SERVICE INSTRUCTION

RUNNING MODIFICATIONS ON

ROTAX® ENGINE TYPE 912/914 (SERIES)

SI-912-020R8

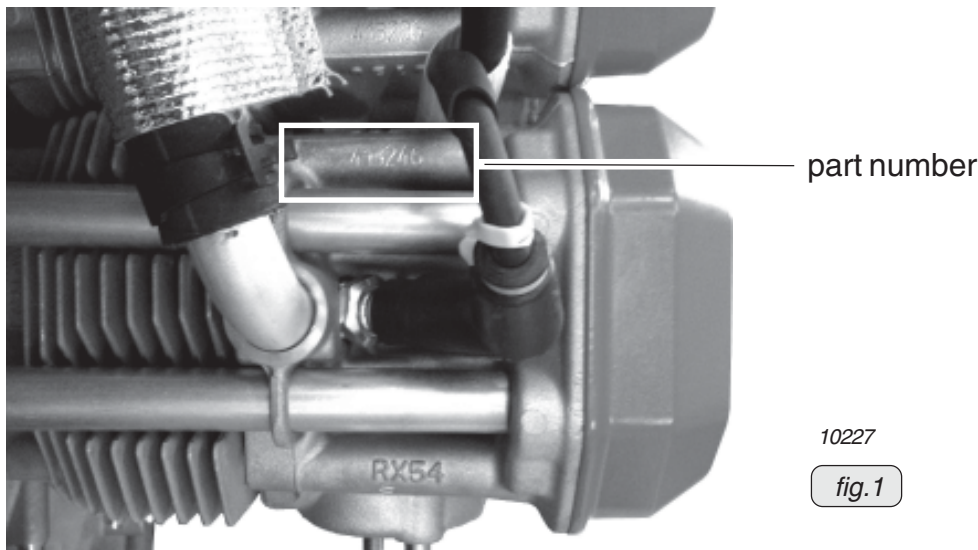
1.2.2) Temperature sensor

Regarding change of position of the temperature sensor, see fig. 2 and fig. 3.

◆ NOTE: Contrary to the current design, the temperature sensor is directly flooded with coolant. Therefore the thread must be sealed with LOCTITE.

1. Clean the thread of the temperature sensor.
2. Apply LOCTITE 243 to the thread of the temperature sensor. Tightening torque 10 Nm (90 in.lb).
3. Plug the respective wiring harness connector into the temperature sensor.
4. Engine assembly.
5. Fill with operating fluids (coolant, oil or fuel). See also chapter 12-20-00 current issue of Maintenance Manual Line for the engine type 912/ 914 Series.
6. Conduct test run. See also chapter 12-20-00 current issue of Maintenance Manual Line for the engine type 912/ 914 Series.

fig. 4

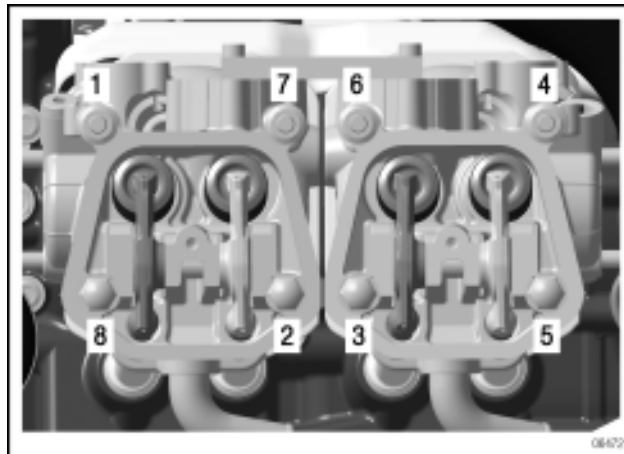
In the course of continuous development a new tightening torque procedure for the installation of the cylinder heads has been introduced.

1. Fasten the cylinder finger-tight and diagonally, at first with M8 collar cap nuts and M8 hex. nuts.
2. Fasten the cylinder heads according to the torque sequence diagram shown in fig. 4.
Tightening torque 10 Nm (90 in.lb) + 120°.

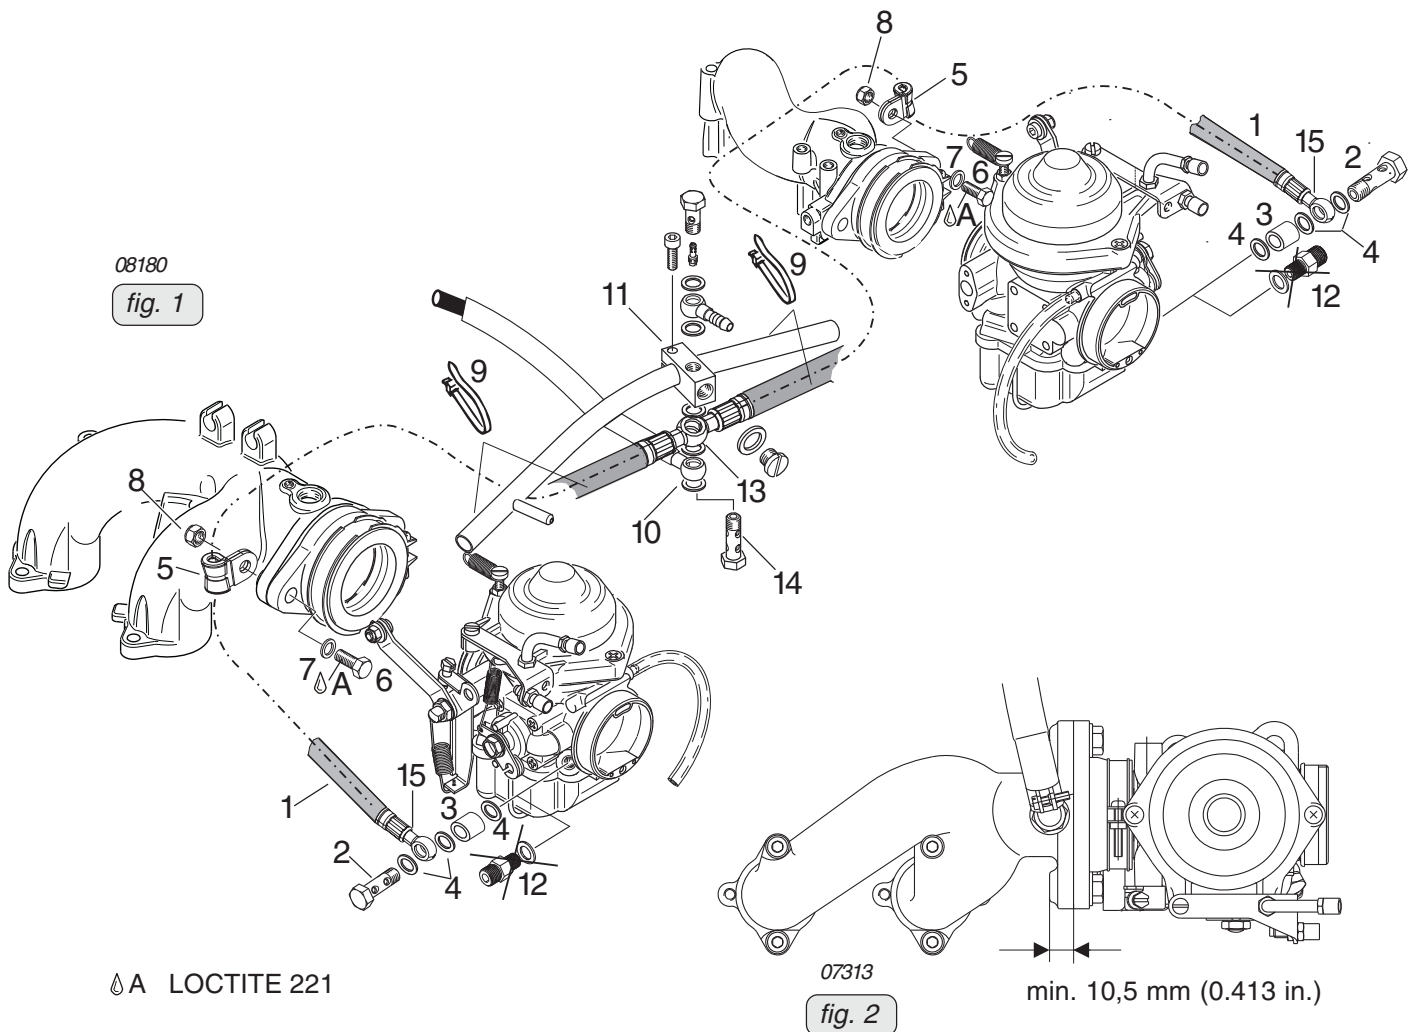
In the course of continuous development and for better assembly and maintenance a new flexible fuel line (part no. 874911) has been introduced.

- mechanical machining at the intake manifold for the attachment of the cable clamp. At engine repair/general overhaul be aware that the fixation of the flexible fuel line needs an appropriate contact surface. If necessary replace the intake manifold or machine the contact surface according to the following instruction.

- Install the flexible fuel line (1) with the double ring hose nipple (13) and sealing ring (10) on the clamp block (11). Tightening torque of banjo screw (14) 10 Nm (90 in. lb.) (see fig. 1).

- For installation on an old style intake manifold perform the following: Remove the intake manifold and machine the nut/clamp contact area until the surface is parallel with the sealing surface of the carb socket. The thickness of the material must not be dressed down less than 10,5 mm (0.413 in.) and should be smooth and flat so that the nut/clamp assembly has an even contact surface (see fig. 2).

08353
fig. 1

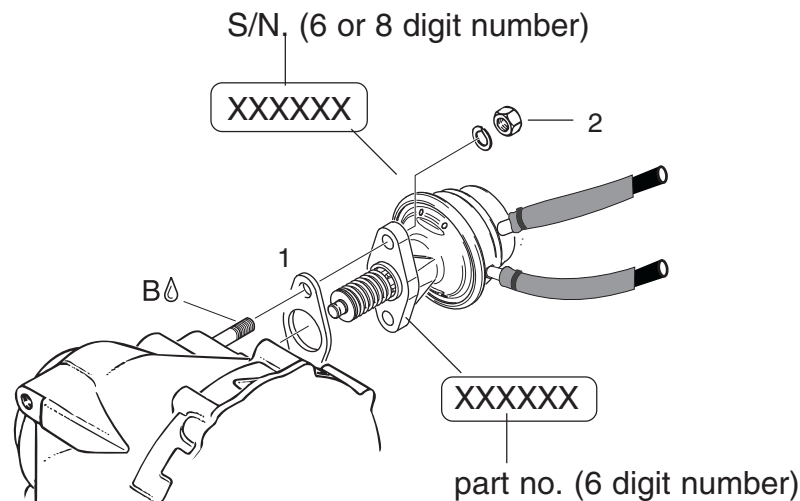
In the course of continuous development a new gasket (1) (part no. 950226) has been introduced.

The gasket is interchangeable.

- ◆ NOTE: On the sealing surfaces of the gearbox housing and the fuel pump no sealing compound has to be used.

fig. 2

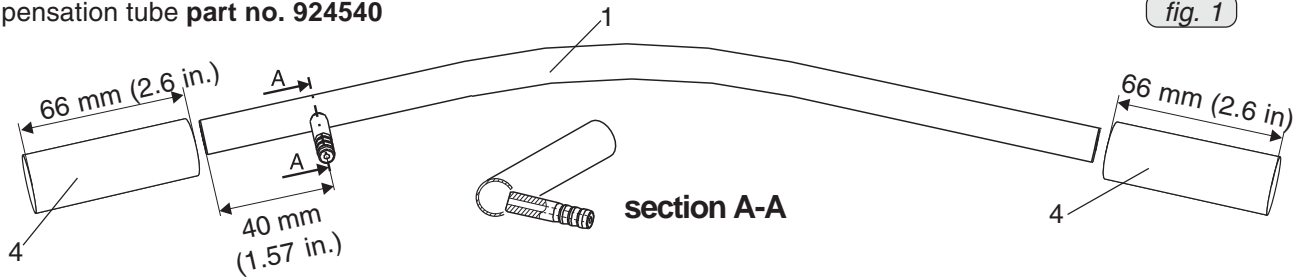
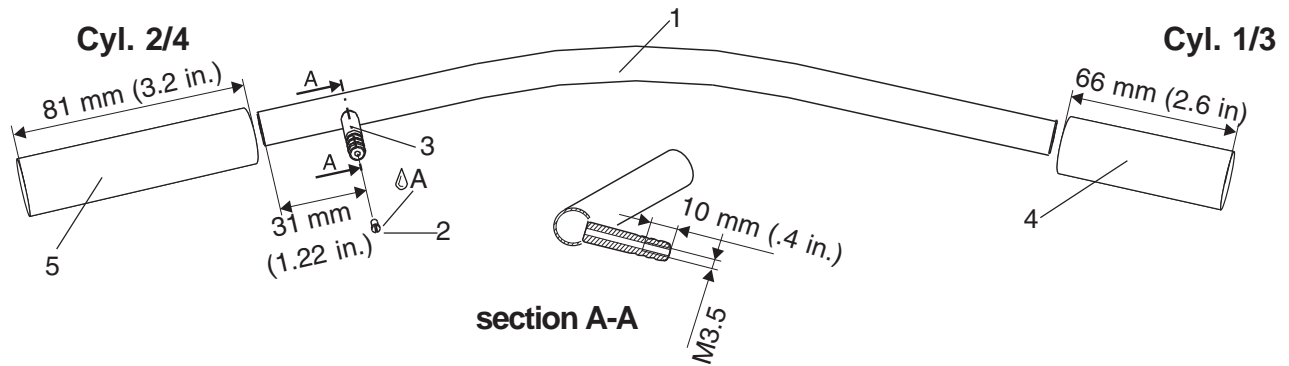
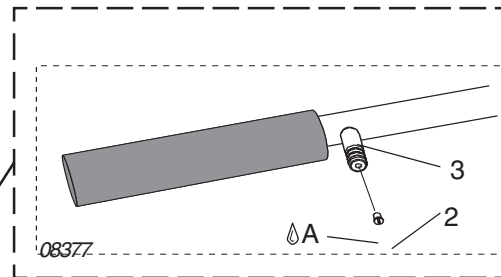
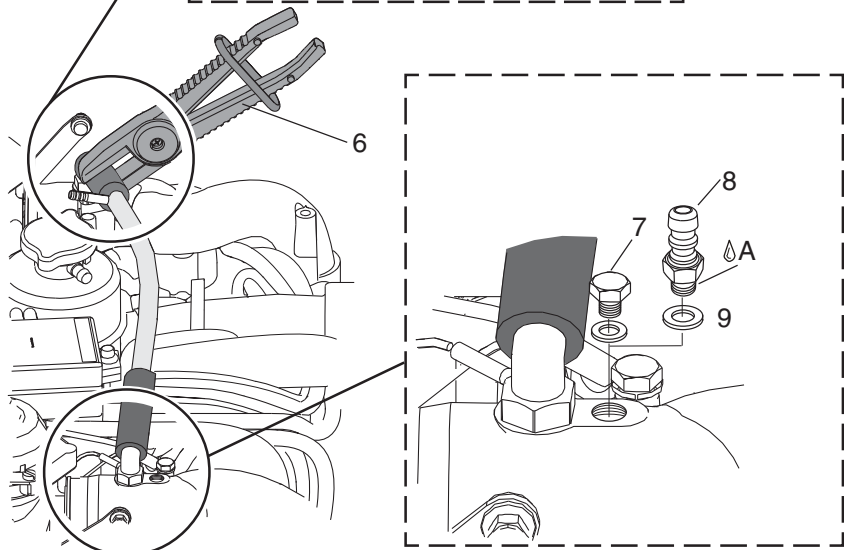
In the course of continuous development a new compensation tube (1) (part no. 924541) has been introduced which the synchronization to make it easier, the tube must not removed.

- position of connection fitting (3) on compensation tube remains approximate constant
- additional screw (2) part no. 940980 for connection fitting (3)
- new tube (4) part no. 956143 (5) part no. 956141

1. Install the vacuum gauge.
2. Clamp the tube with hose clamping pliers (6). Observe the position! The tube (1) must not removed.
3. Unscrew the screw (7).
4. Install the hose nipple M6 (8) with the sealing ring (9).
5. After synchronization tightened the screw M6x6 (7) with LOCTITE 221.

1. Unscrew the screw (2) from the connecting fitting (3) for indicating instrument.

fig. 1

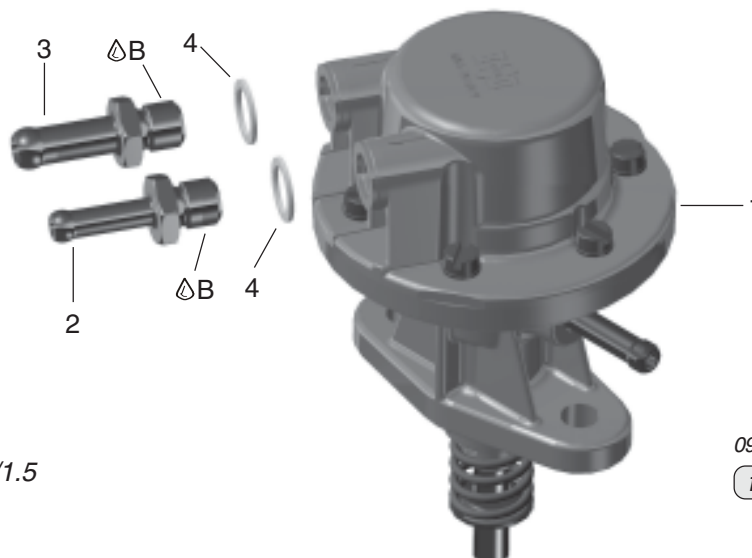
Pump inlet (3):

nipple..... 9/5.7
tightening torque..... 10 Nm (90 in.lb)

Pump outlet (2):

nipple 7/3.8
tightening torque..... 10 Nm (90 in.lb)

09874
fig. 2

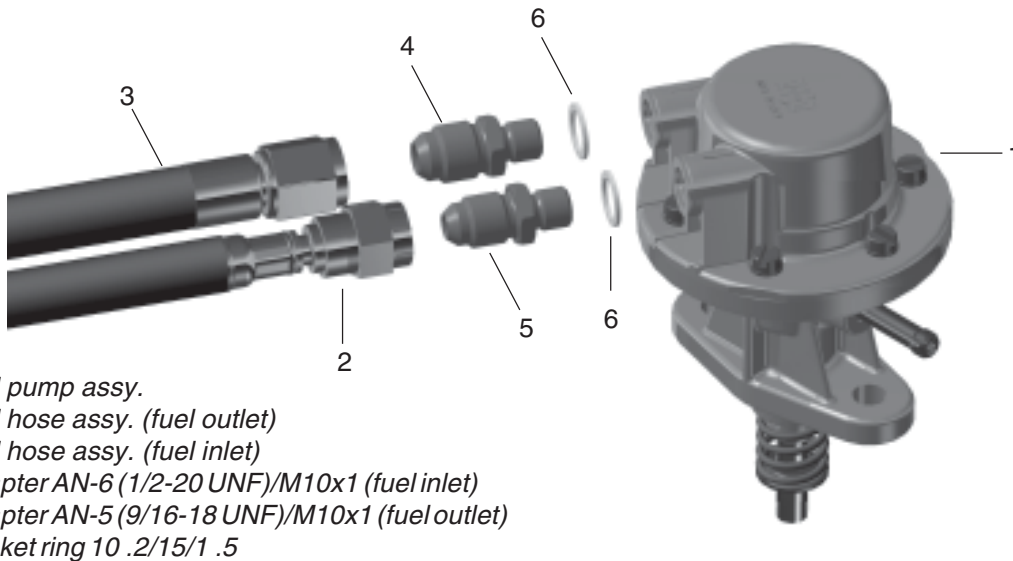
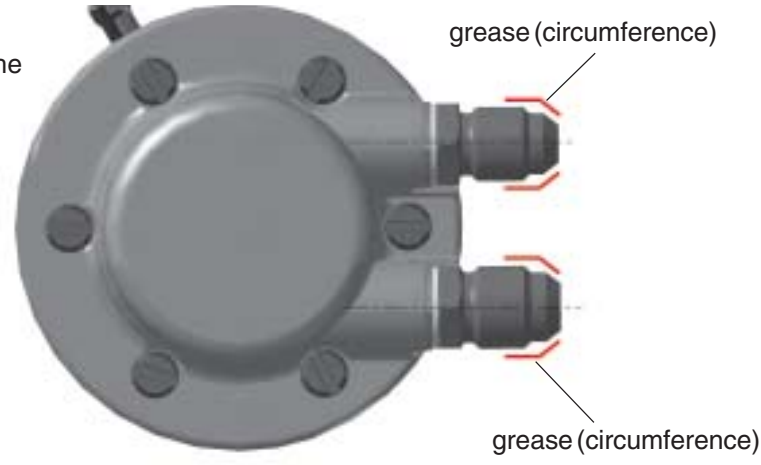
Pump inlet (3):

tightening torque..... 10 Nm (90 in.lb)

Pump inlet (4):

tightening torque..... 32 Nm (23.6 ft.lb)

Pump outlet (5):

tightening torque..... 27 Nm (20 ft.lb)

■ CAUTION: Counterhold the adapter during tightening.

08831
fig. 4

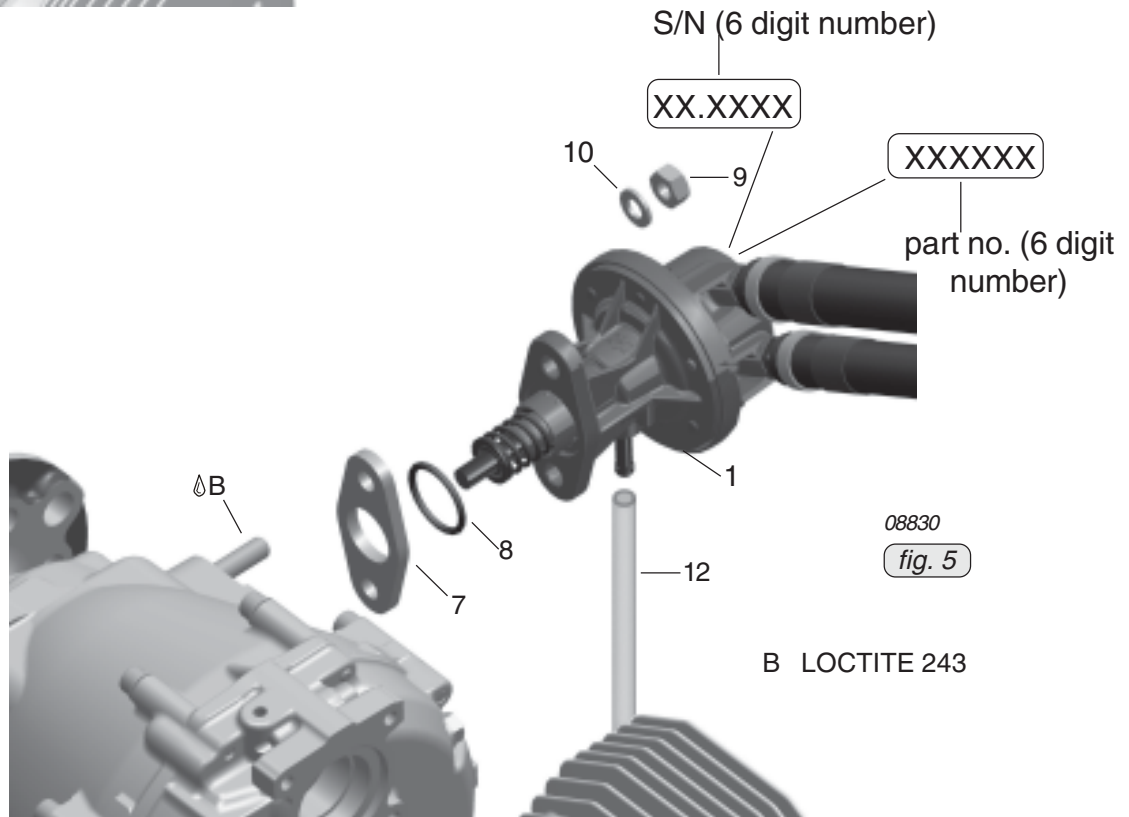
Option 2

Connecting to fuel pump (1) with attached hoses on the fuel hose. See fig. 4.

thread (5)..... AN5-(9/16-18 UNF)

tightening torque: 15 Nm (135 in.lb)

ring hose nipple/fitting (6)..... 3/4 DIN 7642

tightening torque: 15 Nm (135 in.lb)

fig. 1

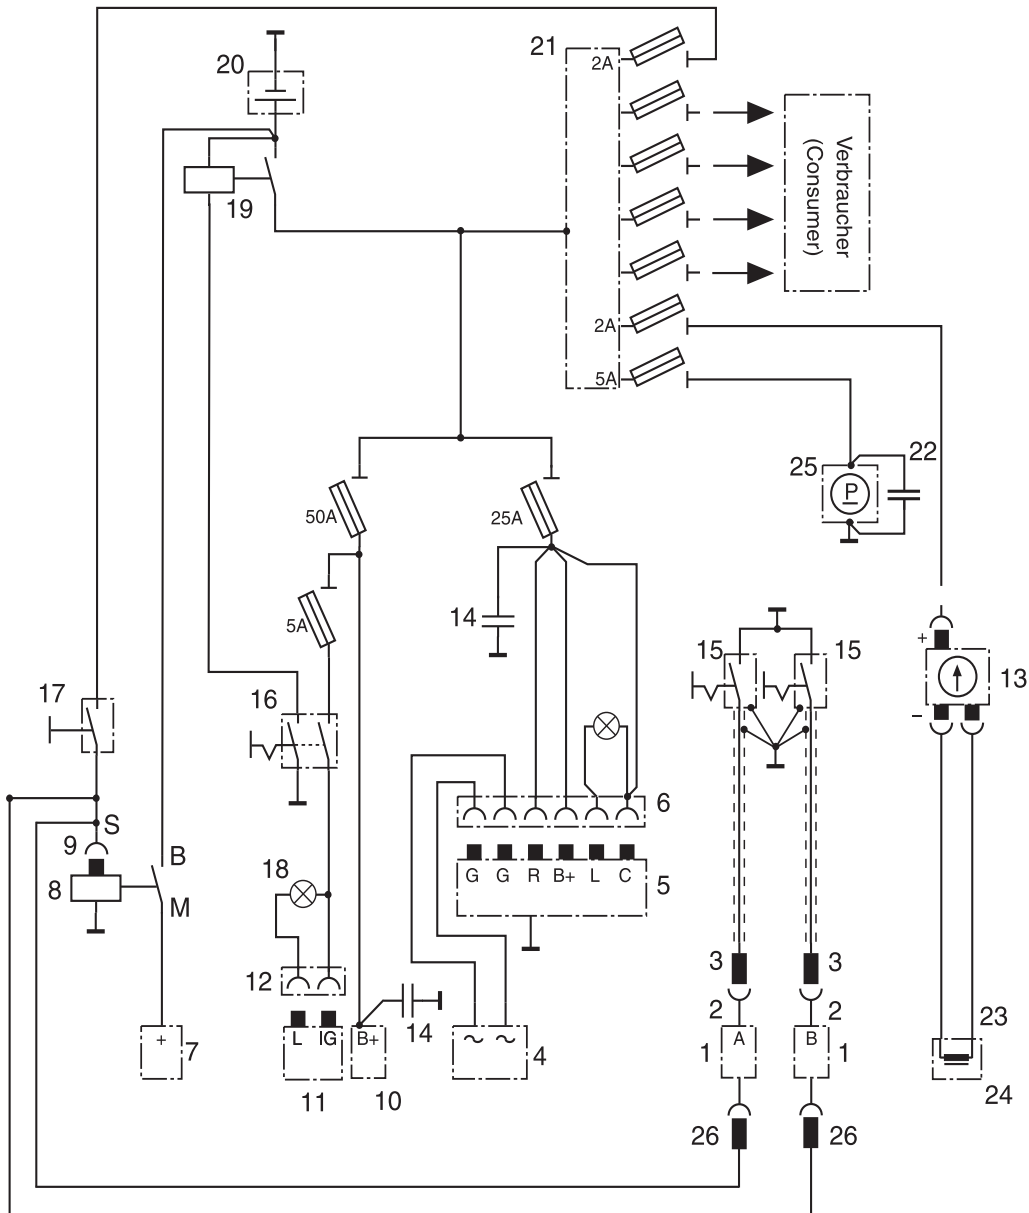
In the course of further development and standardization an electronic module for delayed start up ignition timing has been introduced. This module can be activated by a 12 V signal. Without this optional 12V activation the function works the same way as on the well-proven previous module.

- 1 wire of each module circuit A and circuit B (6-pole) to start relay control signal wire (see position 26 in fig. 1) must be supplied by the aircraft manufacturer. Therefore the rubber plug of the pin terminal must be removed before!
- Time factor for delaying ignition timing at start until switching to advanced ignition: After starting the engine and as soon as the starter/relay is not powered anymore, the engine continues to further run for 3-8 seconds with delayed ignition.
- Do not connect the signal wire to the electric starter motor - as the circuit has not voltage protection.
- Do not power the advanced start terminal permanently with 12V. The delay timer function would be bypassed and charging speed might vary (depending on internal tolerances, trigger gap etc.).
